DOCUMENT - 2024-346P

**Construction of the Dockstader Peel Region Paramedic Services
Reporting Station**

ADDENDUM 3

SS04 Front Elevation
 1:25 A054

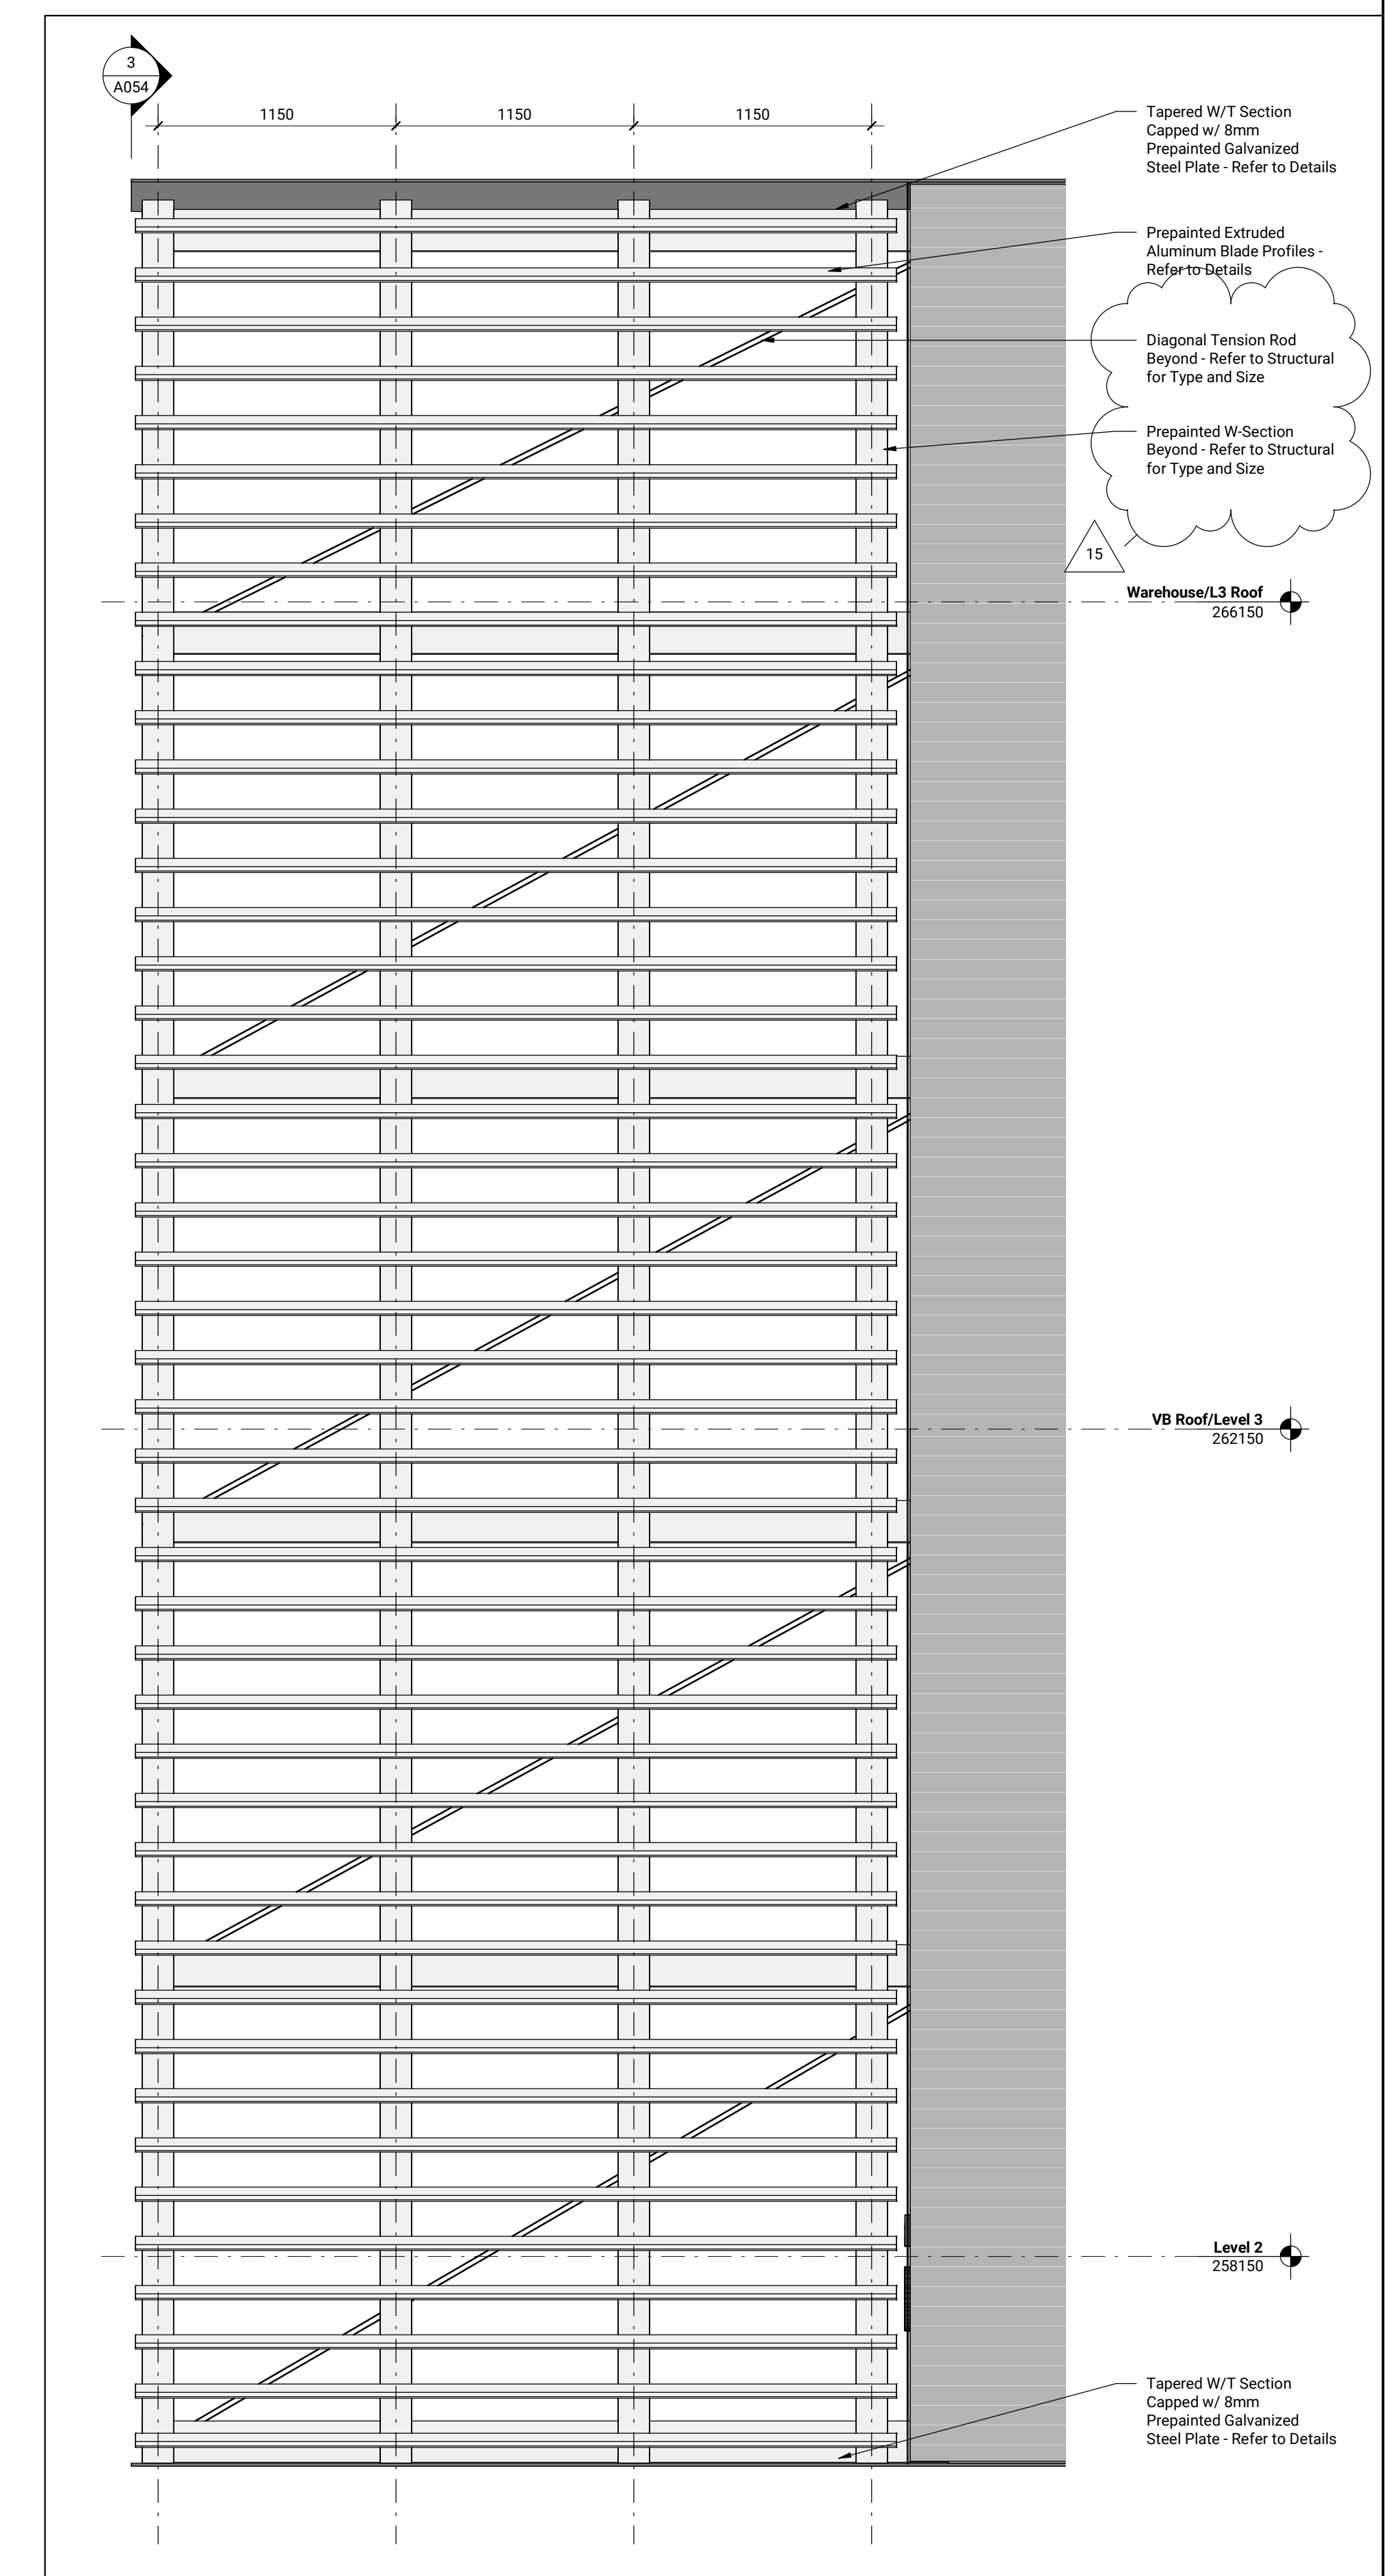
Drawing 4/A054 refers to structural drawing for framing detail of SS04 solar screen wall, but the structural drawings not shown these details. please advise.

Please refer to revised detail 4 on drawing A054 issued as part of Tender Addendum No.3. Note on 4/A054 revised for clarity to "Refer to Structural for Types and Sizing." Framing details to be coordinated through shop drawings after tender award.

East Partial Elevation 1:100 A303

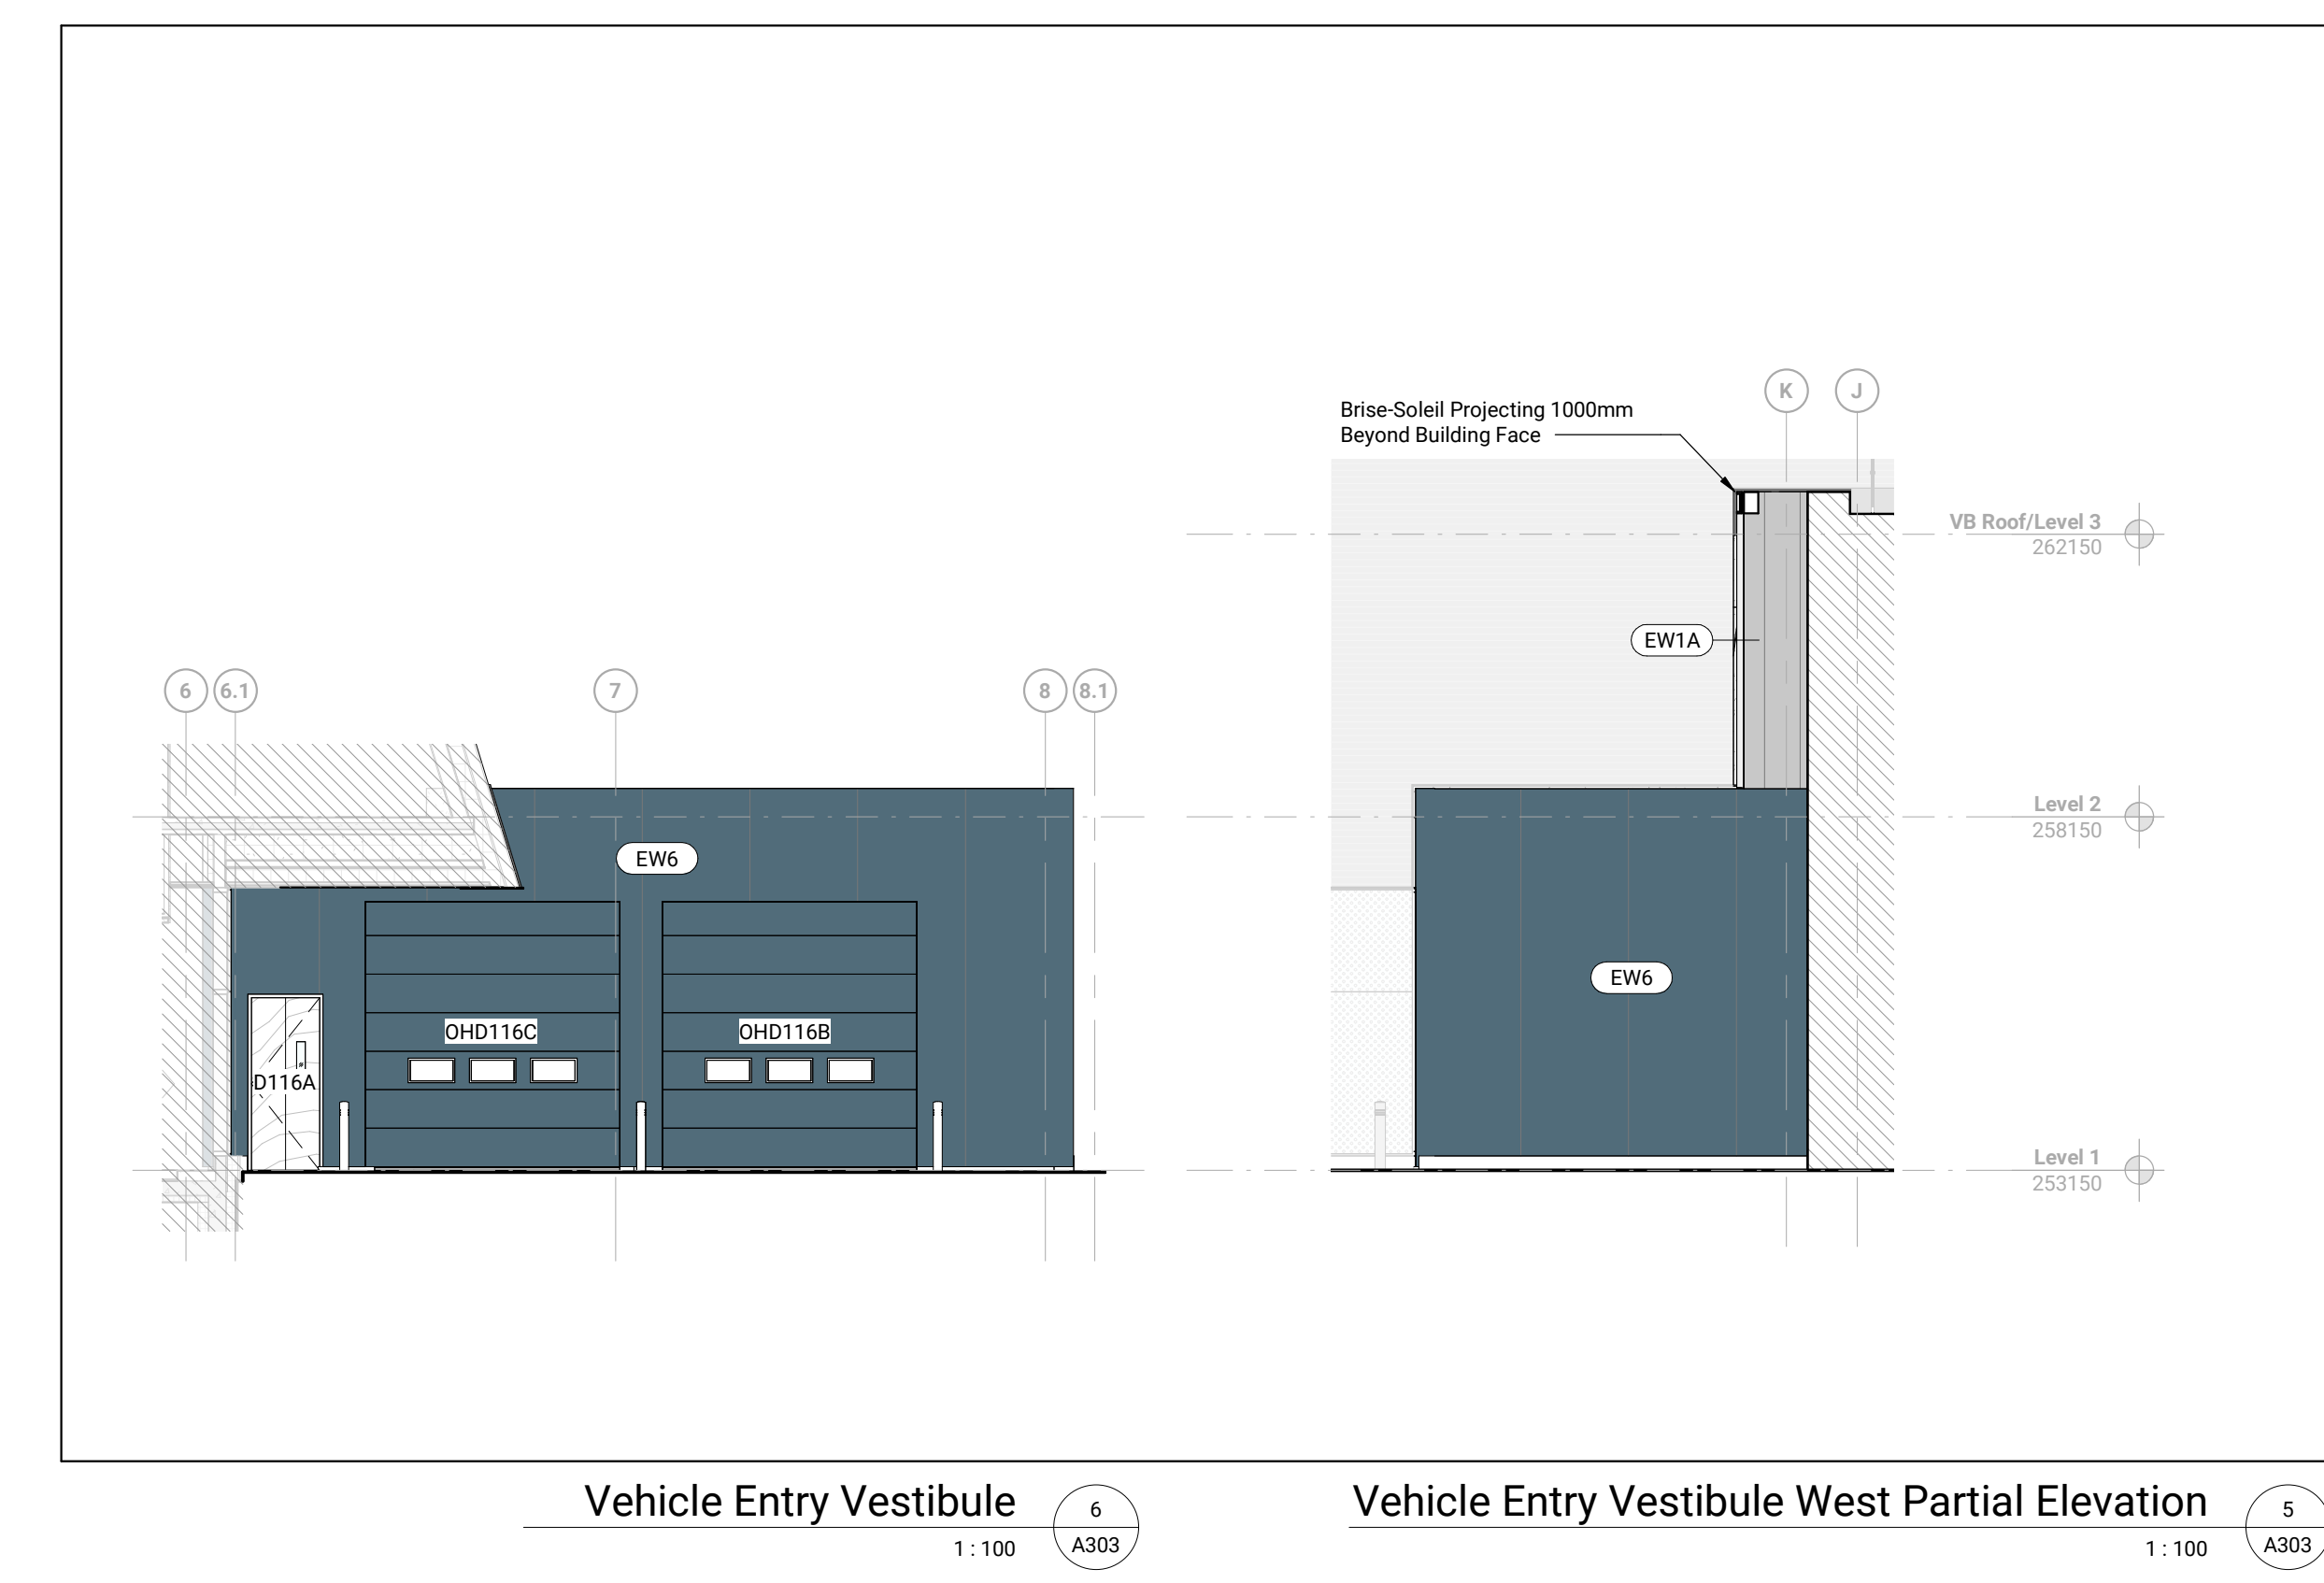
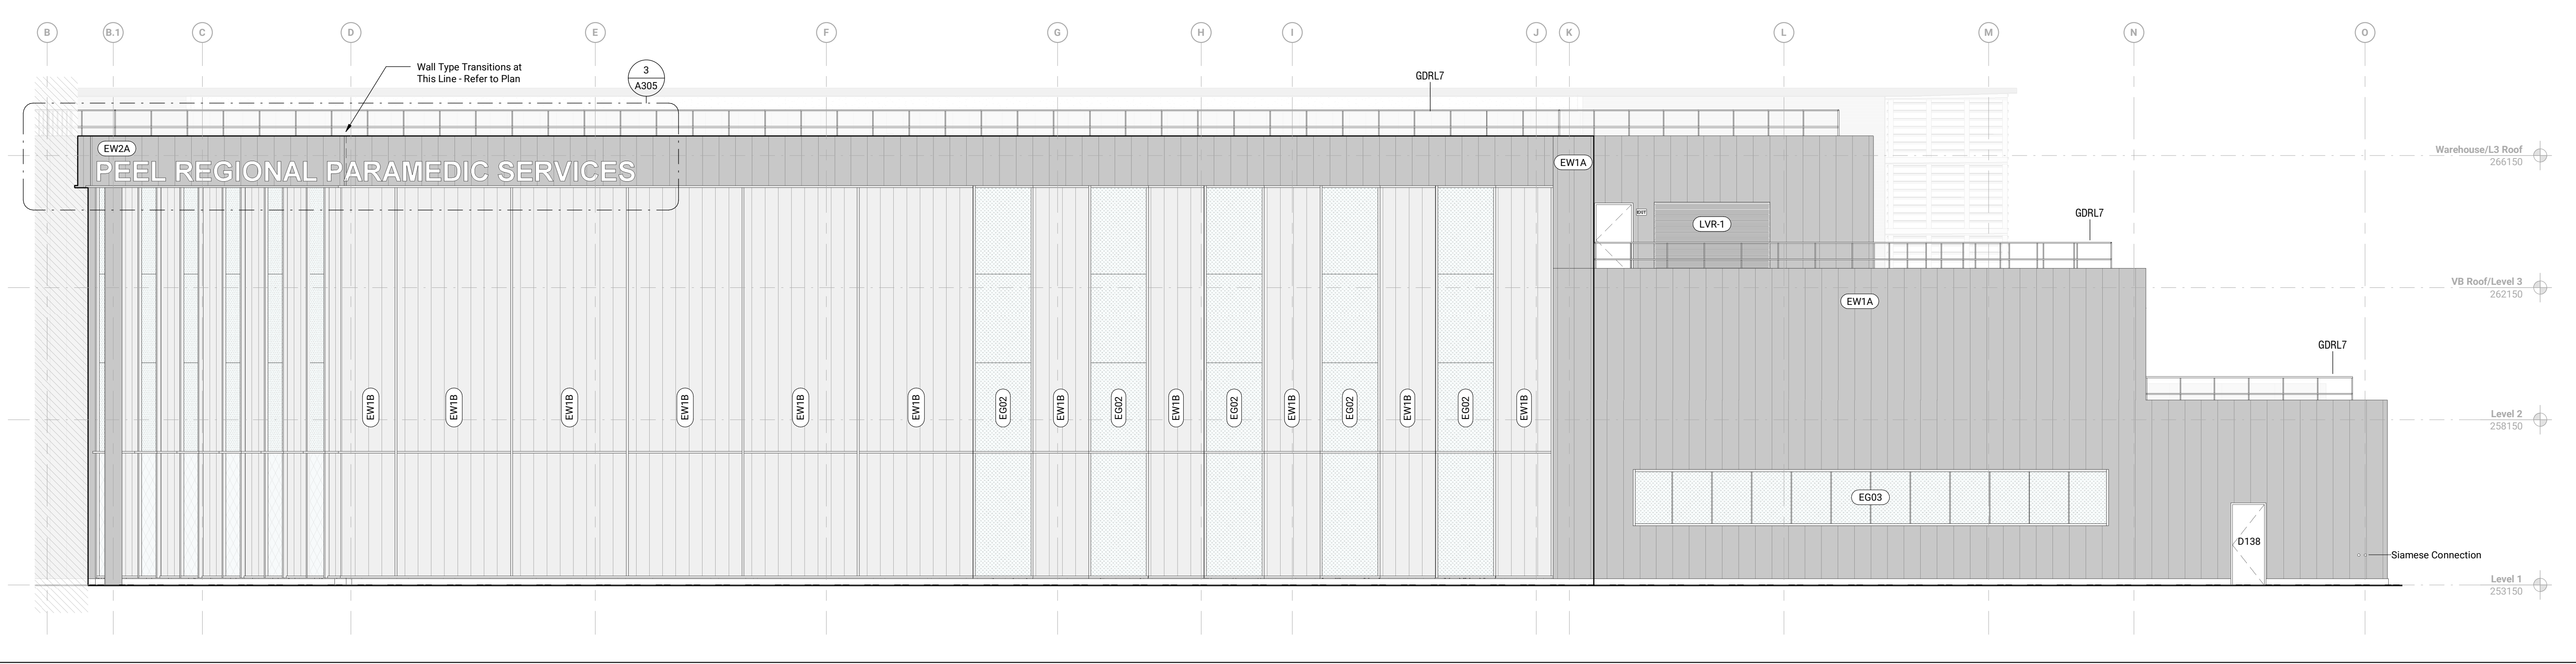
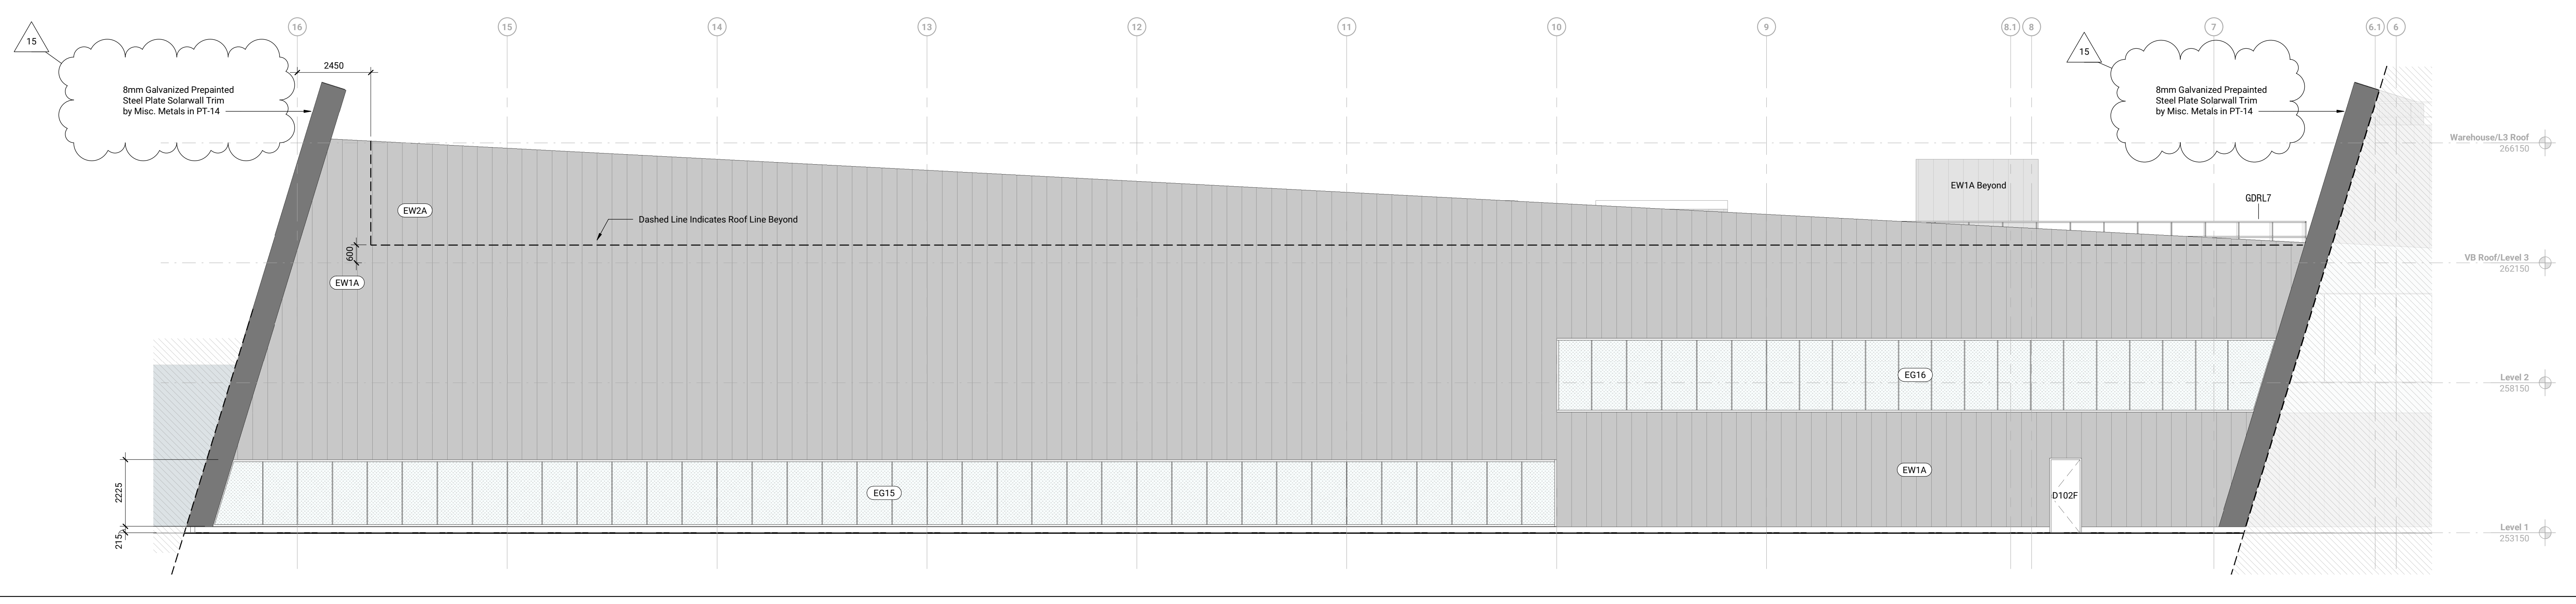
Drawing 3/A303 mentions 6mm galvanized steel plate solar wall trim, but the drawing A054 shade screen schedule not shown this 6mm plate anywhere. Please clarify.

Please refer to revised detail 3 on drawing A303 issued as part of Tender Addendum No.3. Reference to 6mm galvanized steel plate on 3/A303 has been revised to 8mm galvanized steel, as appears in A054.
